June 1, 2016
Project No. 1948F

**RE: Response to Amended Order of Conditions Review Comments
DEP File No. SE049-0693
200 Theodore Rice Boulevard**

Field Engineering Co., Inc. has received the Request for Amended Order of Conditions review comment letter dated May 27, 2016 prepared by Nitsch Engineering and has prepared the following response narrative and supporting documentation for consideration by the Commission.

Project No: 1948
Sheet: 2 OF 2
D-1

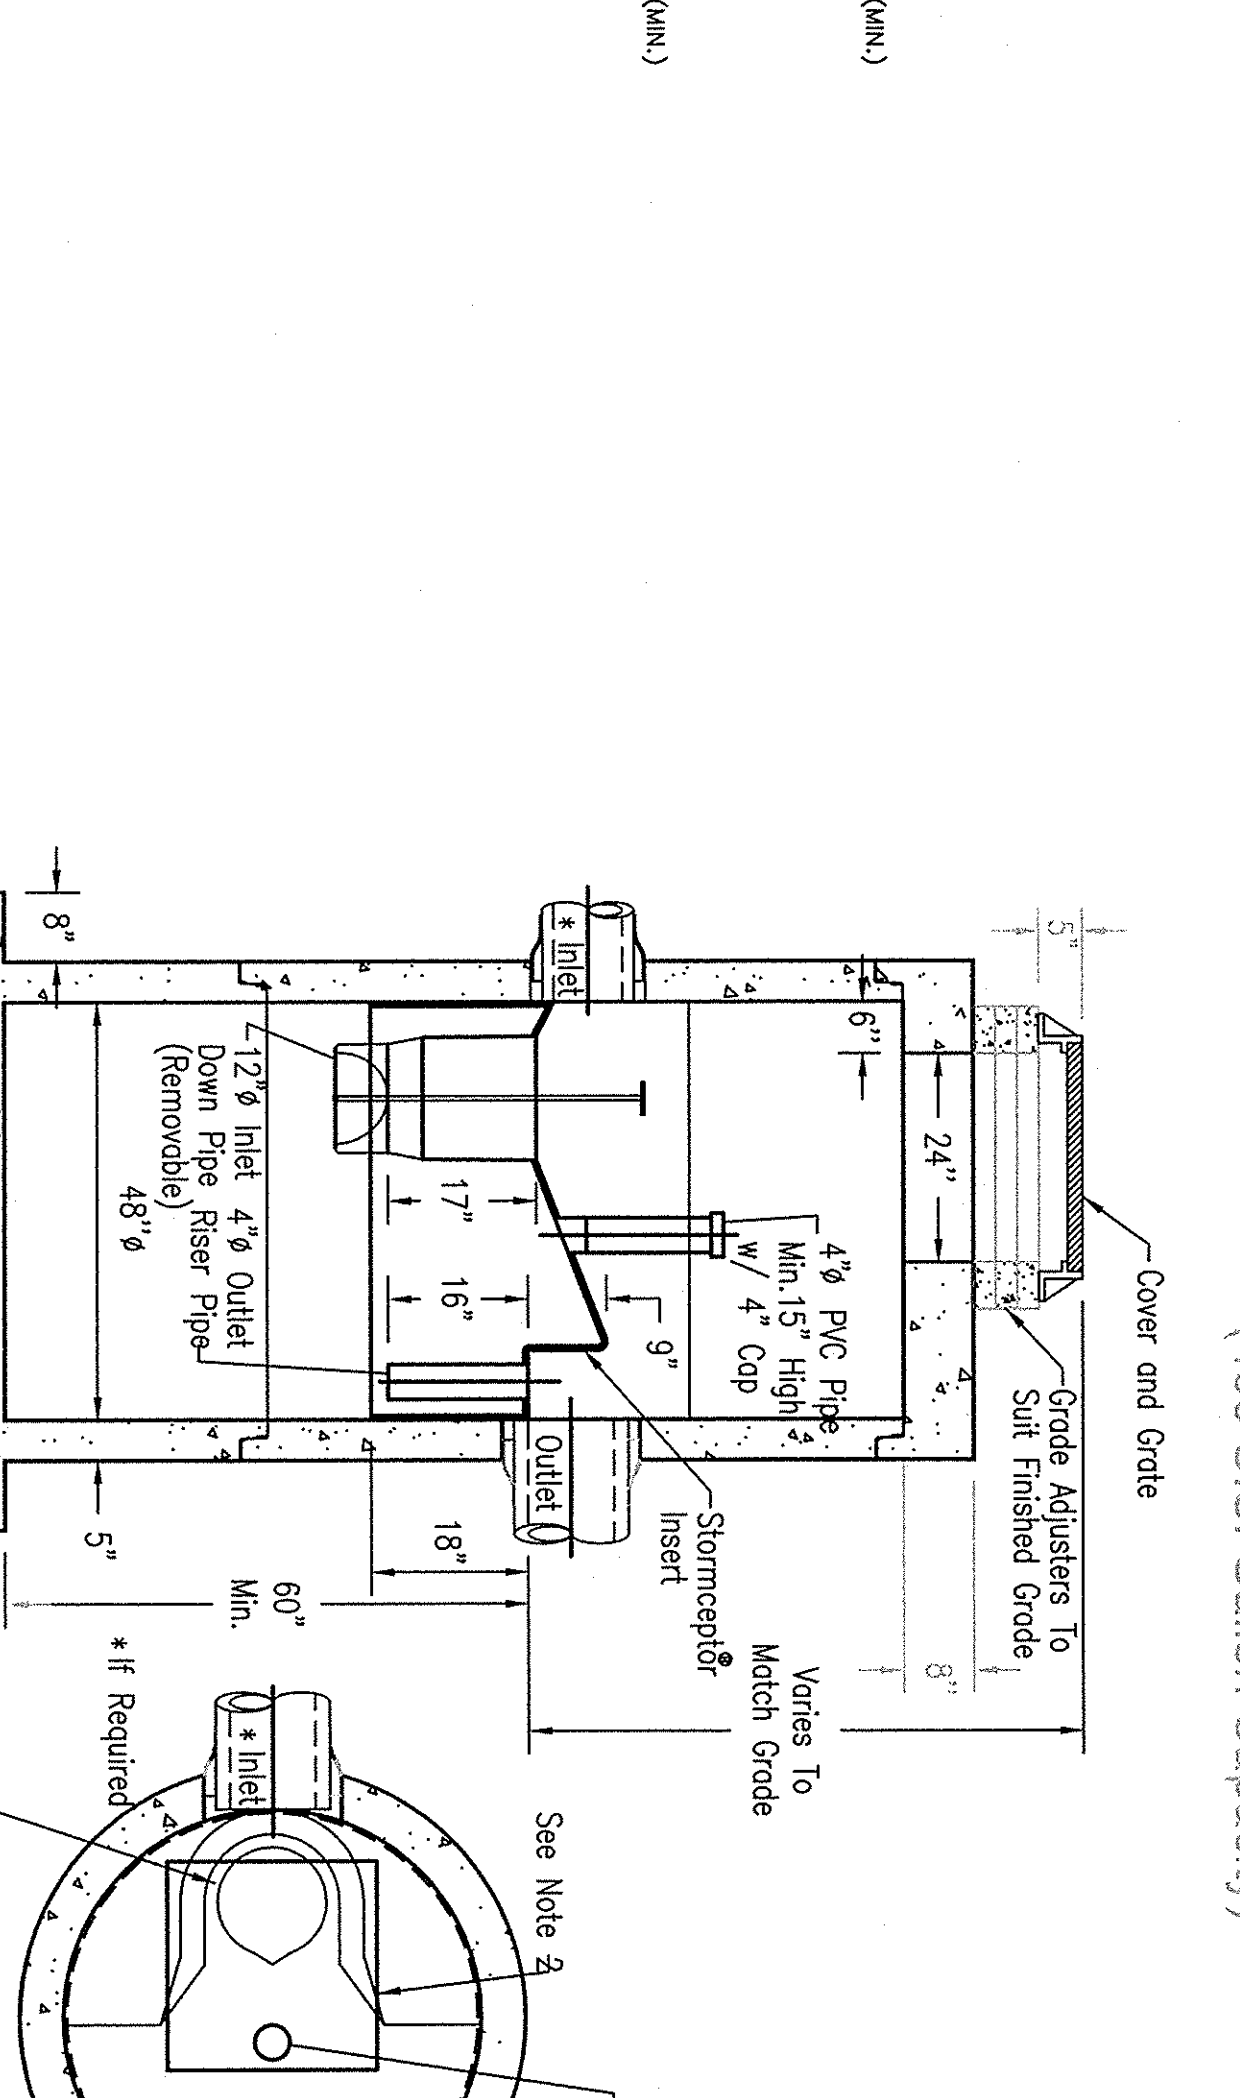
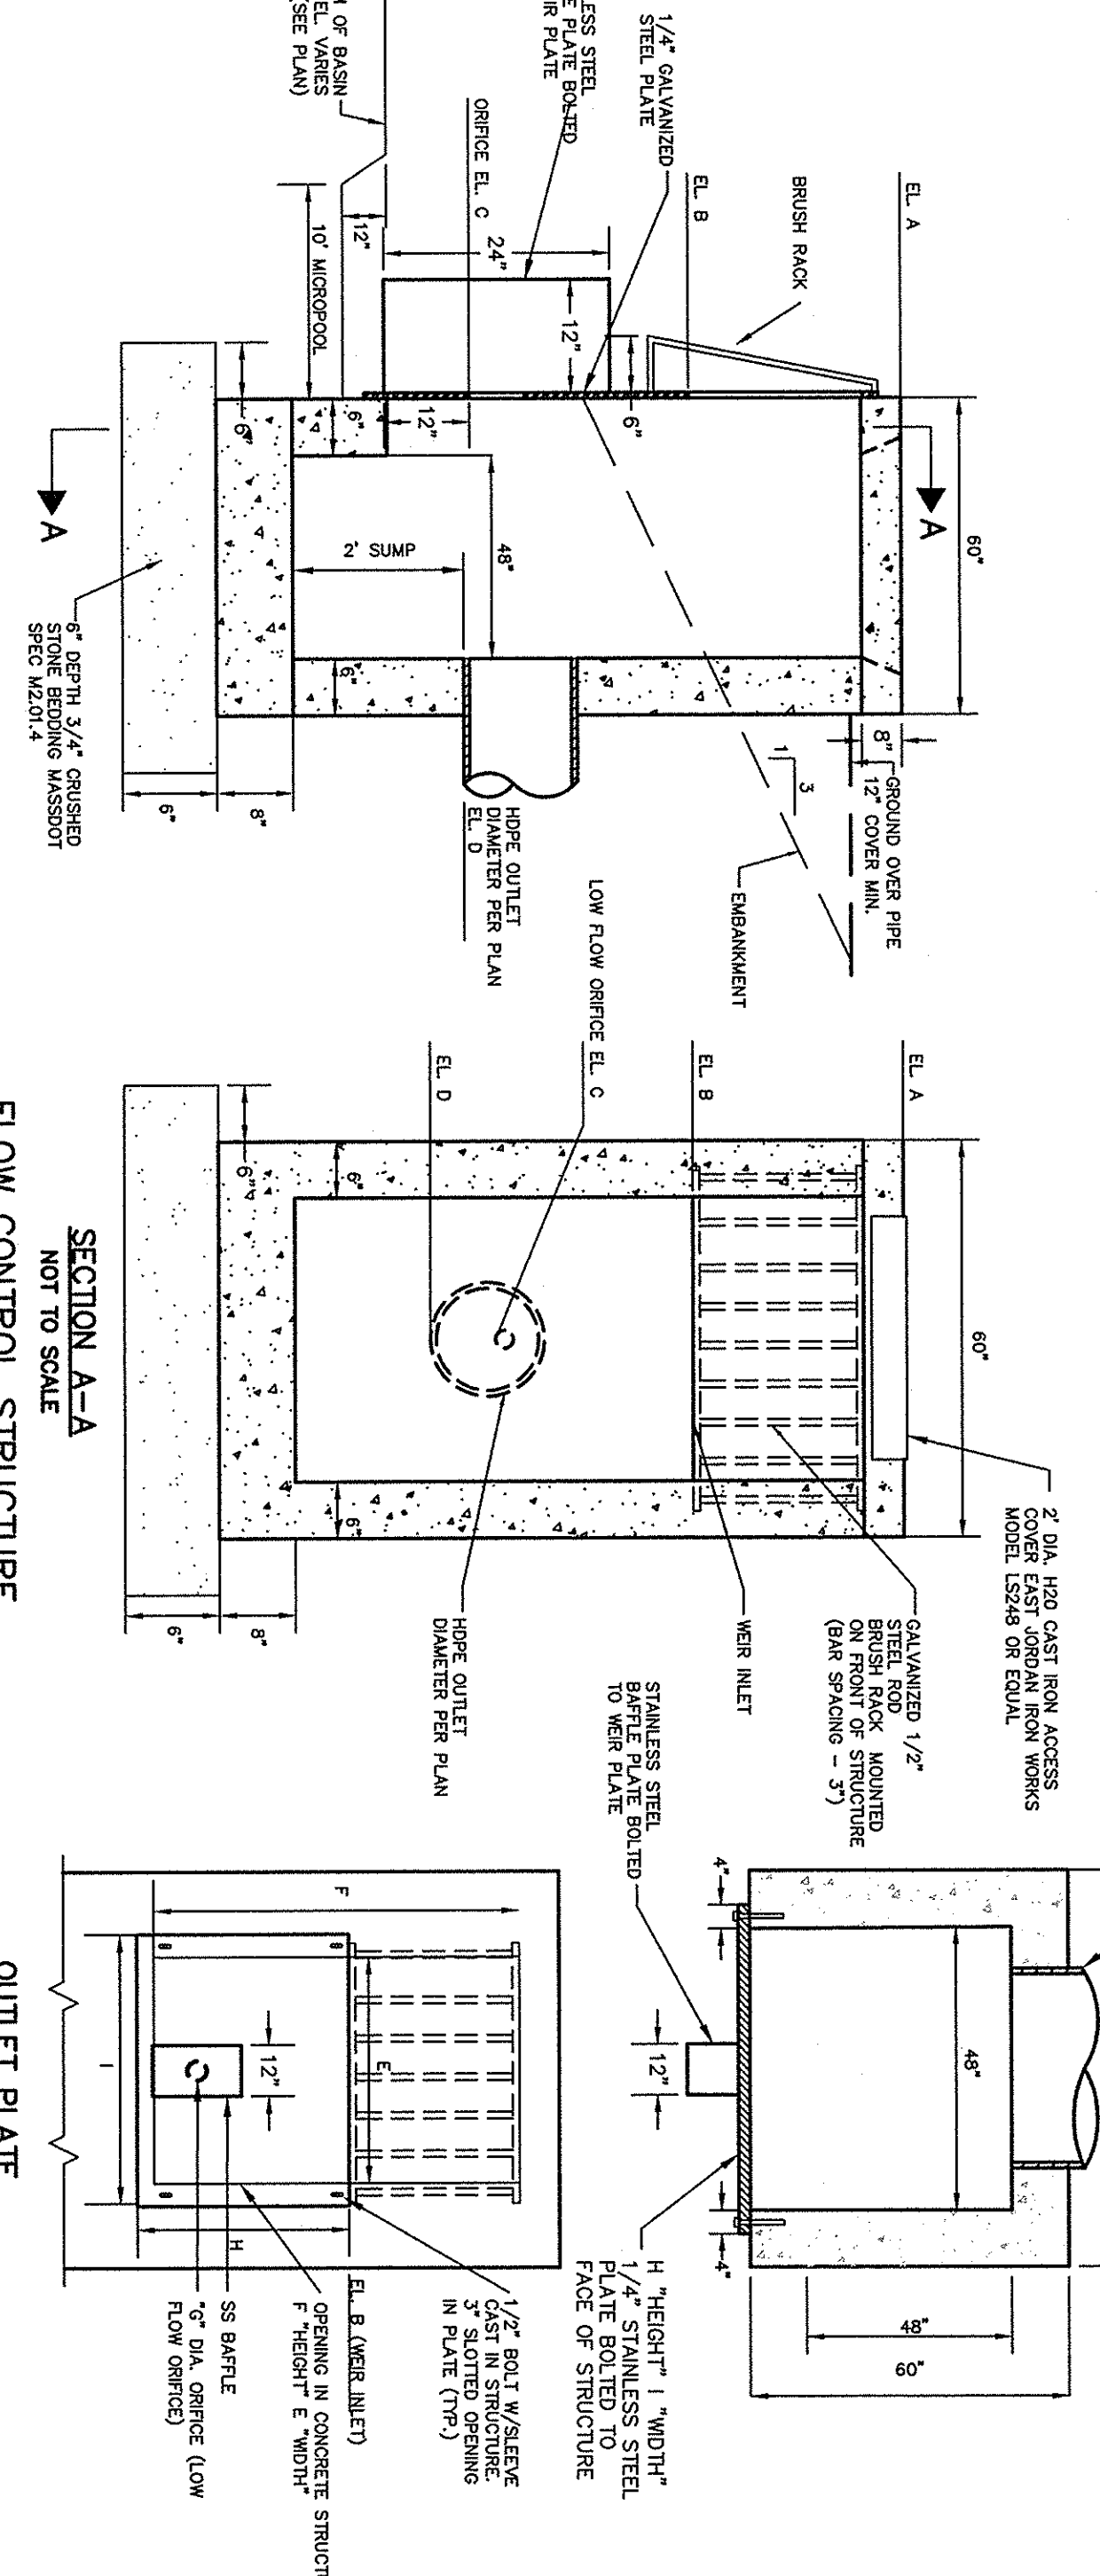
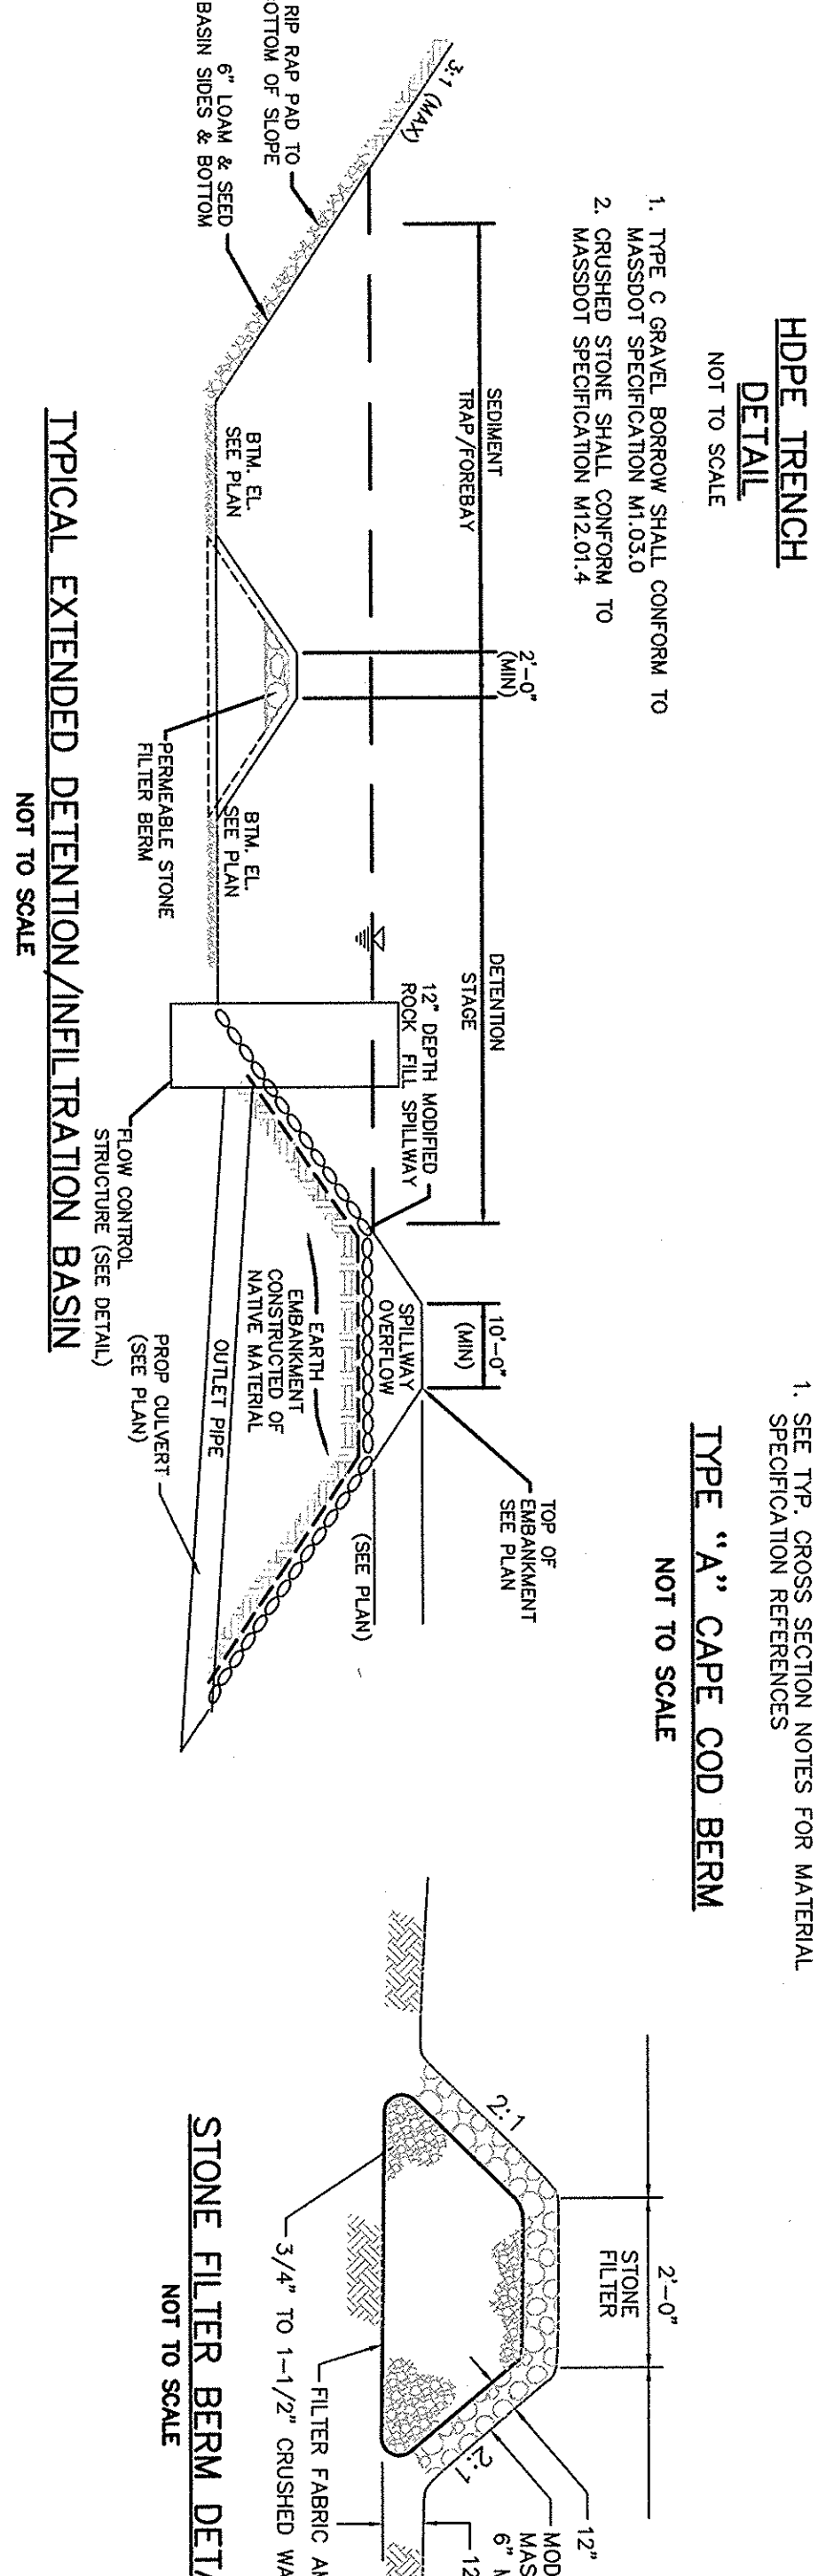
9. The request for an Amended Order of Conditions included one sheet only. There were not any revised details submitted with the revised plans. Comparing the approved calculations with the calculations submitted with the Amended Order of Conditions request indicates that there have been some minor modifications to the outlet control structures from the detention basins. These details should be revised for consistency with the calculations to ensure they are constructed correctly.

RESPONSE: A Revised Detail Sheet showing updated information for the outlet control structures has been prepared and is attached to this Letter.
